Access Compliance Report

Public Rights-of-Way

(Curb Ramps)

Intersection ID: 2457	Main Street: CAMBELLTON_DR	Cross Street: CLARKE_CREEK_PY	Location: NW
ADA ID: FDF33E472C60	Ramp Type: PerpDiag	Initial Pass/Fail: Fail	Overall Compliance: No Severity Score: 33.75

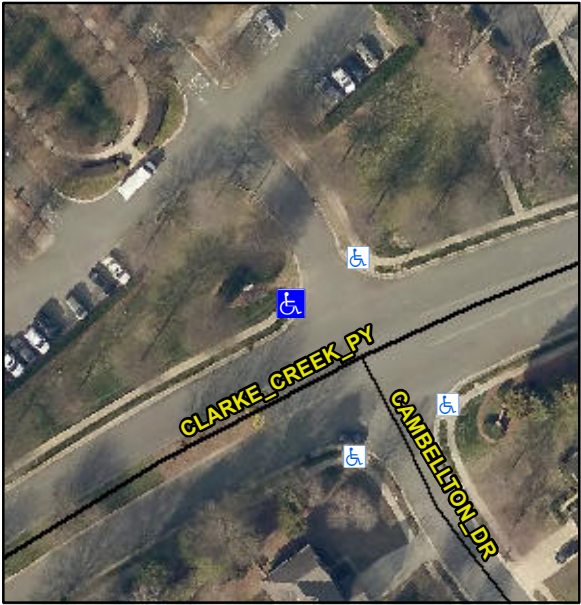
Codes/Mitigation Info/Possible Solution			Field Measurements/Component Compliance		
	Possible Solutions:		Compliance	Description	Data
	Remove & Replace Curb Ramp With Two New Directional Ramps or Equivalent.		No	Ramp Length (in)	47.0
			No	Ramp Width (in)	43.0
			N/A	Flare Type LT	N/A
			N/A	Flare Slope LT (%)	N/A
			N/A	Flare Traversable LT?	N/A
			N/A	Landing Length (in)	N/A
			N/A	Landing Width (in)	N/A
			N/A	Landing Slope (%)	N/A
			N/A	Landing X Slope (%)	N/A
			N/A	Landing Curb? (Y/N)	N/A
			N/A	Shared Landing?	N/A
			N/A	Gutter Ponding?	N/A
			N/A	Gutter Lip Ht (in)	N/A
			No	Painted X Walk1?	N/A
				X Walk 1 Direction	To S
			N/A	X Walk 1 Width (in)	N/A
				X Walk 1 Slope (%)	4.8
				X Walk 1 X Slope (%)	3.3
			N/A	Ramp inside XWalk1?	N/A
<p>Surveyor Notes:</p> <p>N/A</p> <p>PROW/ADA:</p> <p>R304.5.1, R304.2.2, R304.5.3</p>			N/A	Flare Type RT	N/A
			N/A	Flare Slope RT (%)	N/A
			N/A	Flare Traversable RT?	N/A
